RENESAS TECHNICAL UPDATE

Product Category	MPU/MCU		Document No.	TN-RL*-A029A/E	Rev.	1.00
Title	Correction for Incorrect Description Notice RL78/L13 Descriptions in the User's Manual: Hardware Rev. 2.00 Changed		Information Category	Technical Notification		
Applicable Product	RL78/L13 Group	Lot No. All lots	Reference Document	RL78/L13 User's Manual: Hardware Rev. 2.00 R01UH0382EJ0200 (Dec. 2013)

This document describes misstatements found in the RL78/L13 User's Manual: Hardware Rev. 2.00 (R01UH0382EJ0200).

Incorrect:
Figure 14-71. Timing Chart of SNOOZE Mode Operation (once startup)
(Type 1: DAPmn = 0, CKPmn = 0)

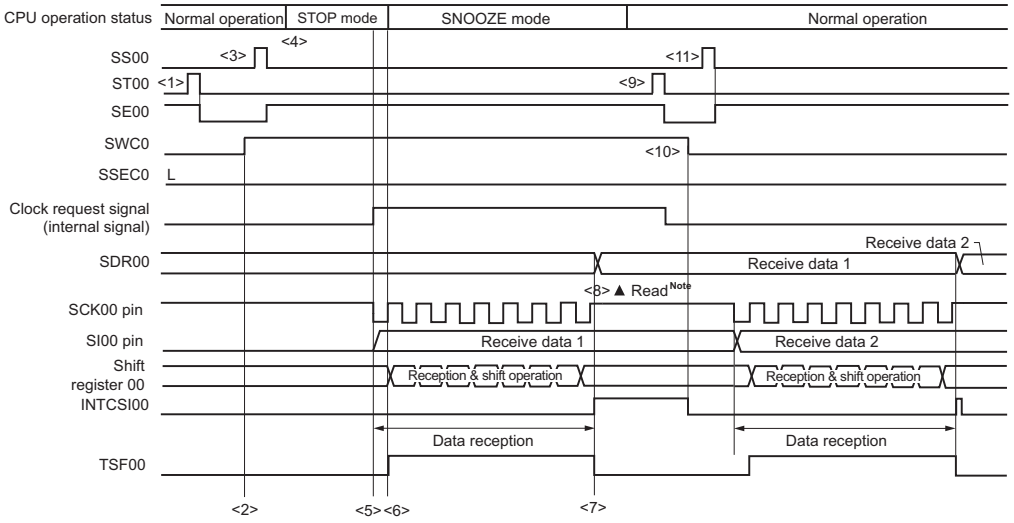
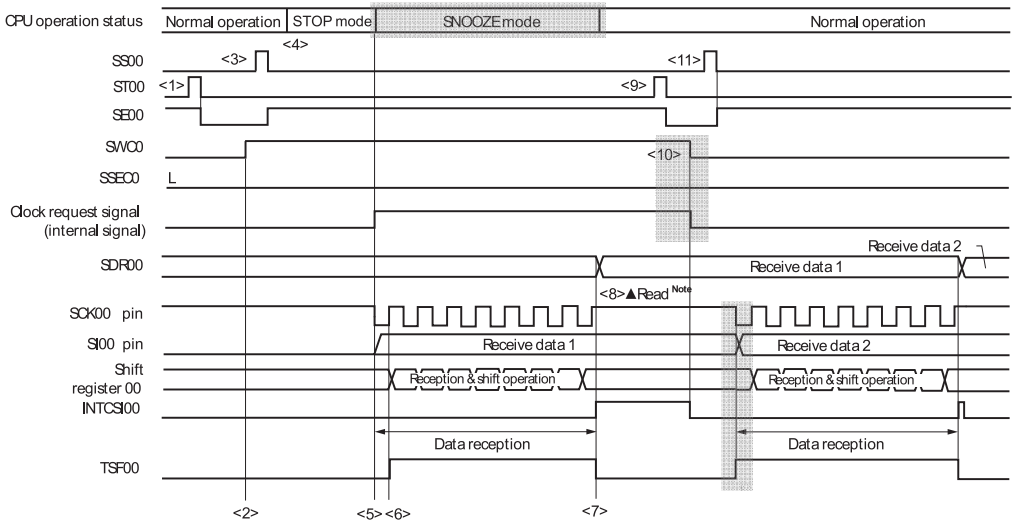
It is correction of "CPU operation status", "Clock request signal (internal signal)" and "TSF00" in this Figure.

Correct:
Figure 14-71. Timing Chart of SNOOZE Mode Operation (once startup)
(Type 1: DAPmn = 0, CKPmn = 0)

Figure 14-73. Timing Chart of SNOOZE Mode Operation (continuous startup)
(Type 1: DAPmn = 0, CKPmn = 0)

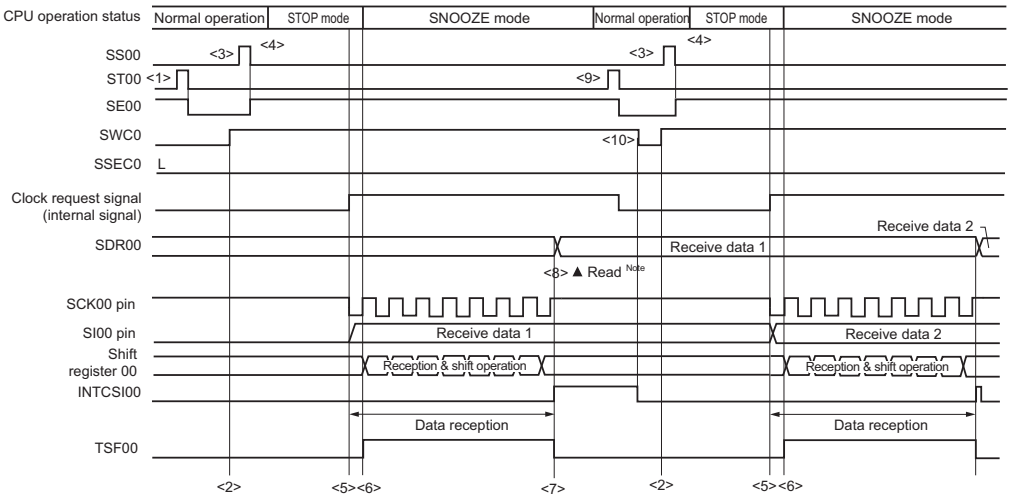
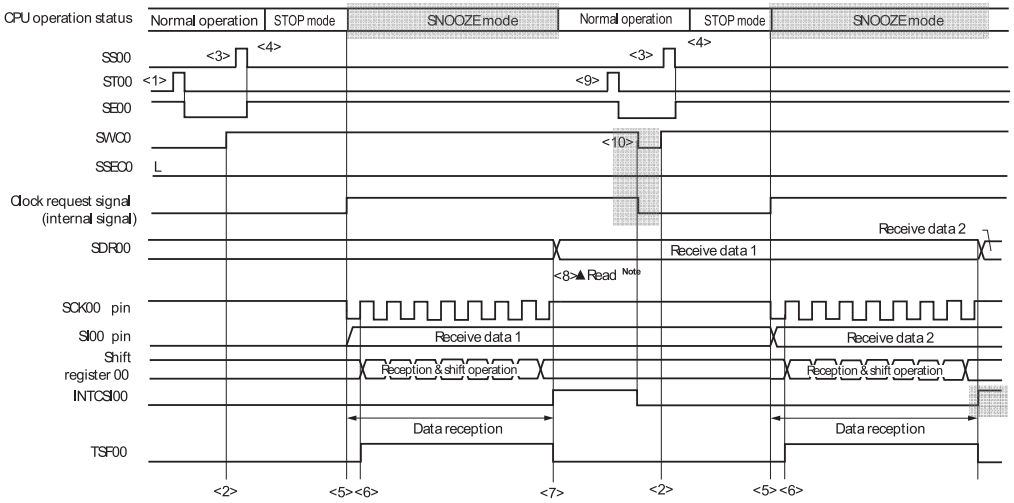
It is correction of “CPU operation status”, “Clock request signal (internal signal)” and “INTCSI00” in this Figure.

Figure 14-73. Timing Chart of SNOOZE Mode Operation (continuous startup)
(Type 1: DAPmn = 0, CKPmn = 0)

Figure 14-90. Timing Chart of SNOOZE Mode Operation (EOCm1 = 0, SSECm = 0/1)

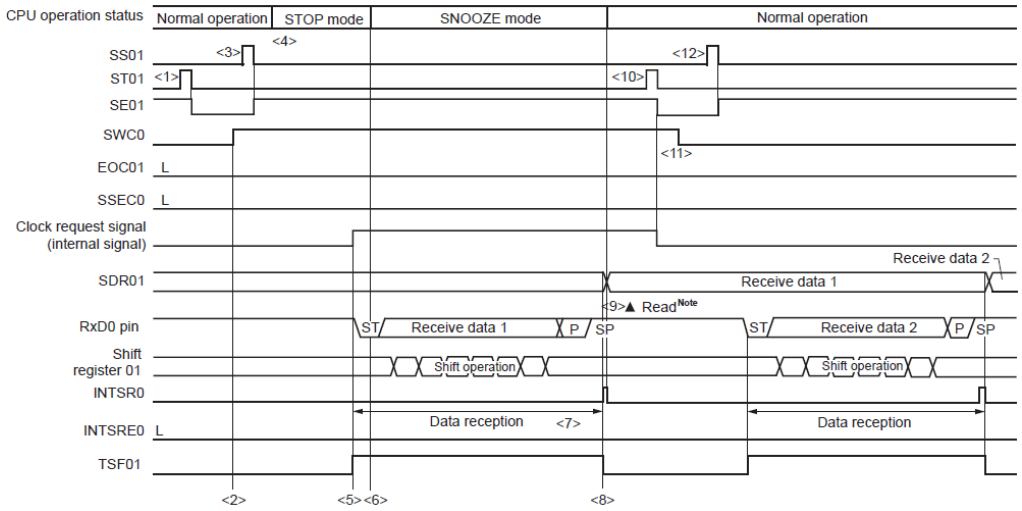
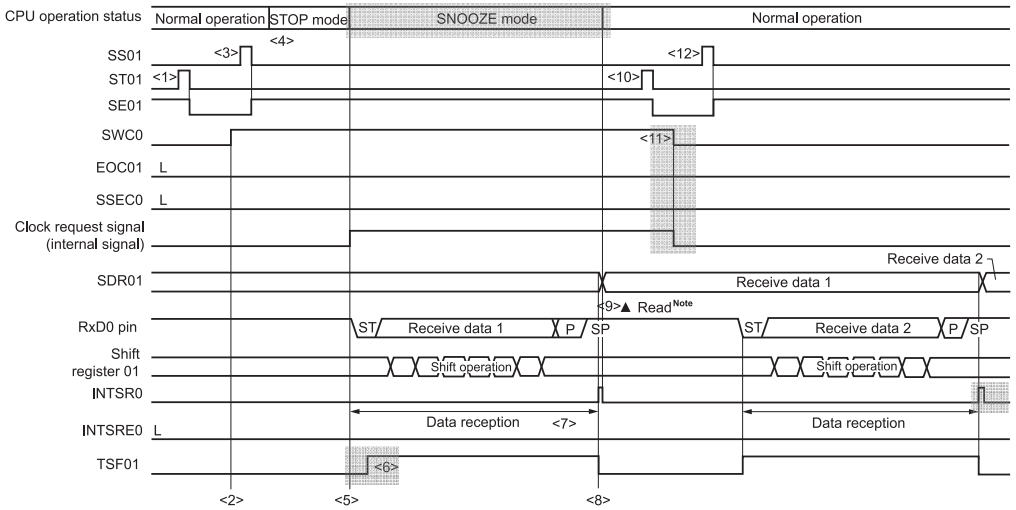
It is correction of “CPU operation status”, “Clock request signal (internal signal)”, “INTSR0” and “TSF01” in this Figure.

Figure 14-90. Timing Chart of SNOOZE Mode Operation (EOCm1 = 0, SSECm = 0/1)

Figure 14-91. Timing Chart of SNOOZE Mode Operation (EOCm1 = 1, SSECm = 0)

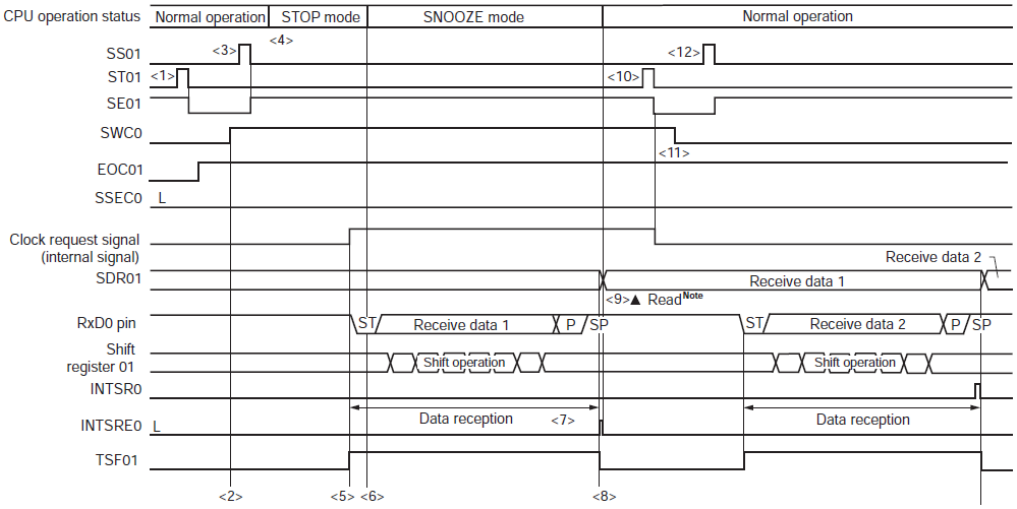
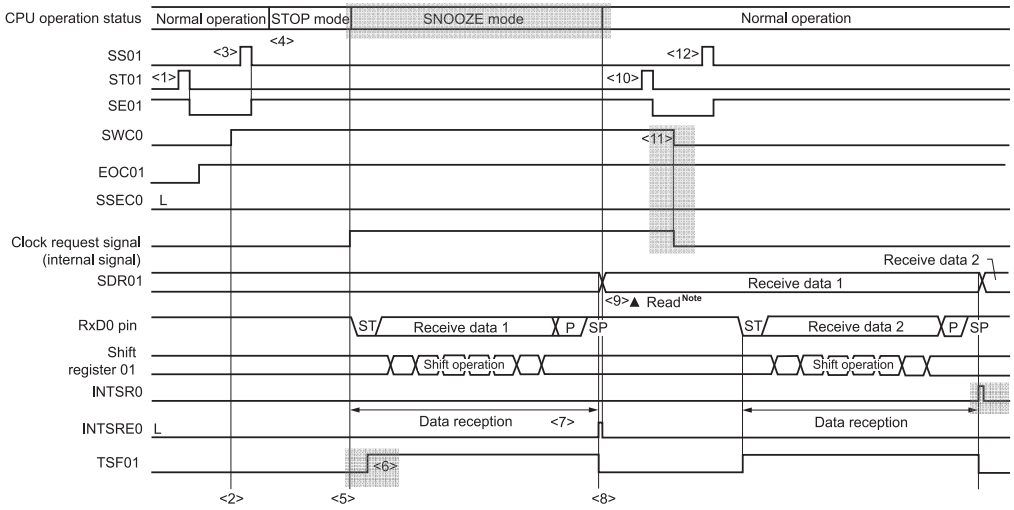
It is correction of “CPU operation status”, “Clock request signal (internal signal)”, “INTSR0” and “TSF01” in this Figure.

Figure 14-91. Timing Chart of SNOOZE Mode Operation (EOCm1 = 1, SSECm = 0)

Figure 14-93. Timing Chart of SNOOZE Mode Operation (EOCm1 = 1, SSECm = 1)

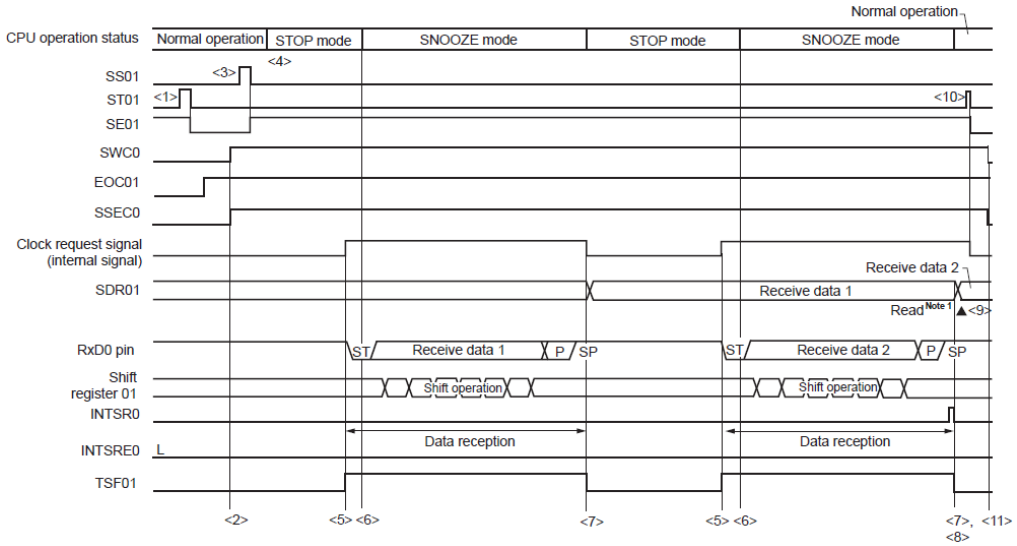
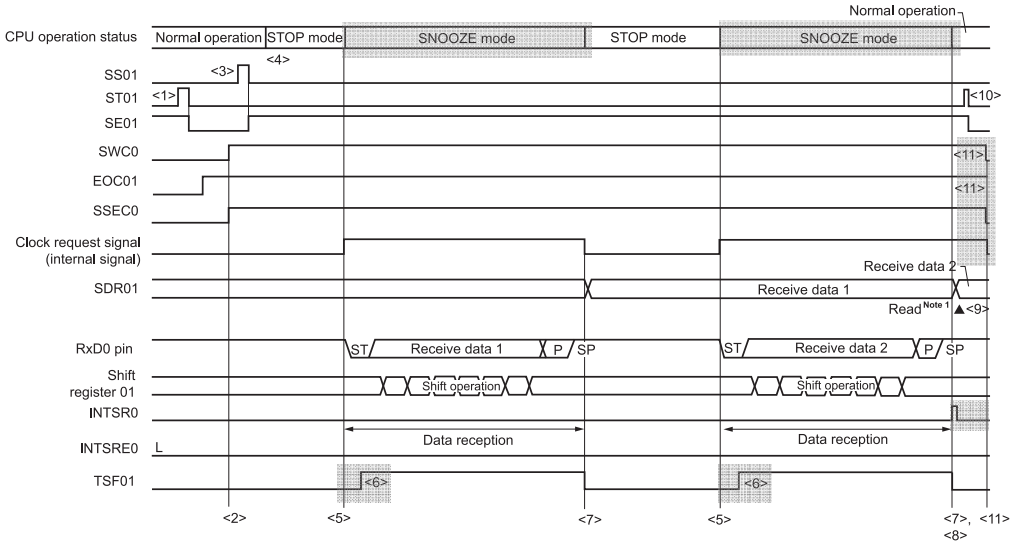
It is correction of “CPU operation status”, “Clock request signal (internal signal)”, “INTSR0” and “TSF01” in this Figure.

Figure 14-93. Timing Chart of SNOOZE Mode Operation (EOCm1 = 1, SSECm = 1)

8. 32.8 Data Memory STOP Mode Low Supply Voltage Data Retention Characteristics (Page 1056)

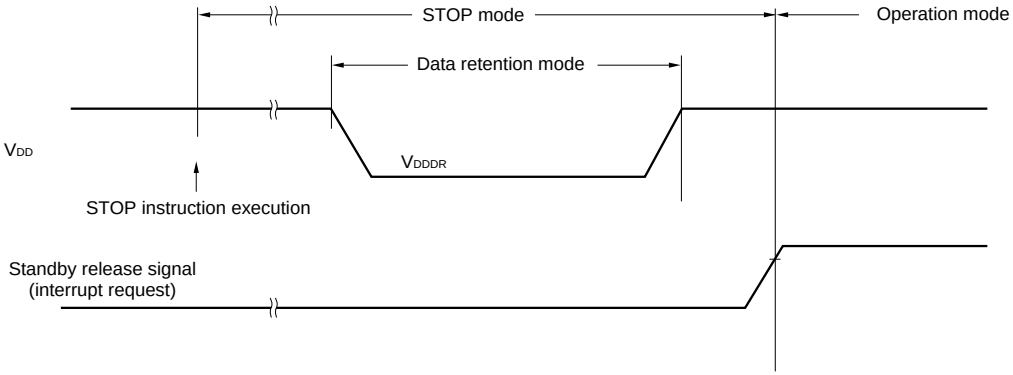
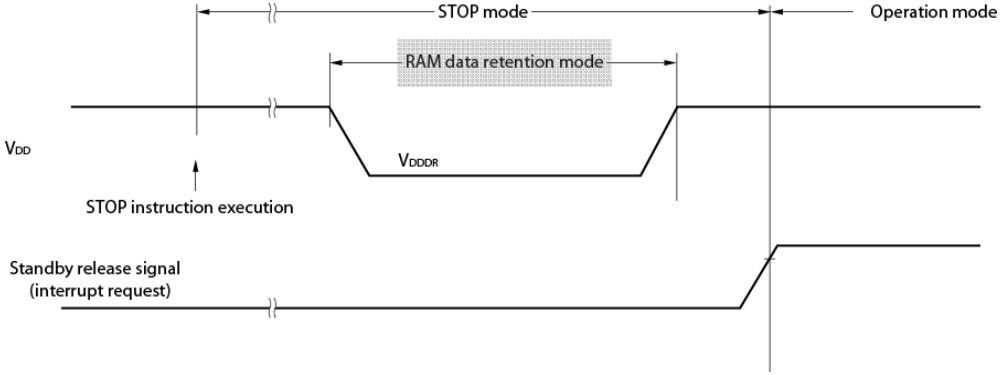
Note The value depends on the POR detection voltage. When the voltage drops, the data is retained before a POR reset is effected, but data is not retained when a POR reset is effected.

32.8 RAM Data Retention Characteristics

Note This depends on the POR detection voltage. For a falling voltage, data in RAM are retained until the voltage reaches the level that triggers a POR reset but not once it reaches the level at which a POR reset is generated.

10. 33.8 Data Memory STOP Mode Low Supply Voltage Data Retention Characteristics (Page 1114)

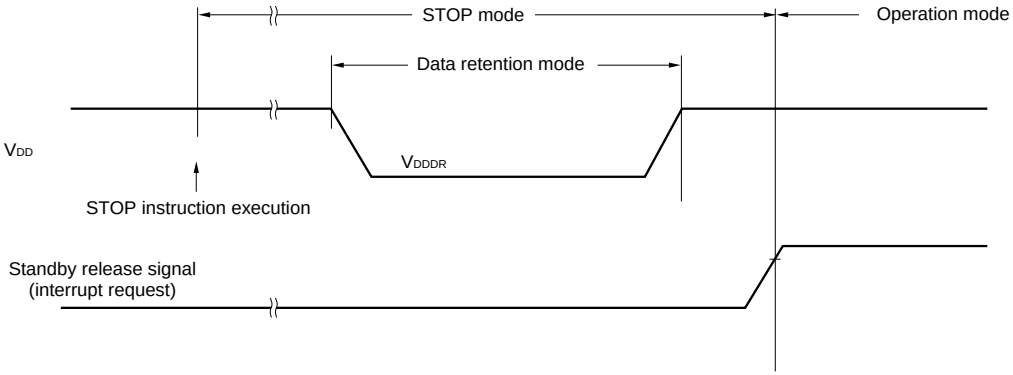
Note The value depends on the POR detection voltage. When the voltage drops, the data is retained before a POR reset is effected, but data is not retained when a POR reset is effected.

33.8 RAM Data Retention Characteristics

Note This depends on the POR detection voltage. For a falling voltage, data in RAM are retained until the voltage reaches the level that triggers a POR reset but not once it reaches the level at which a POR reset is generated.
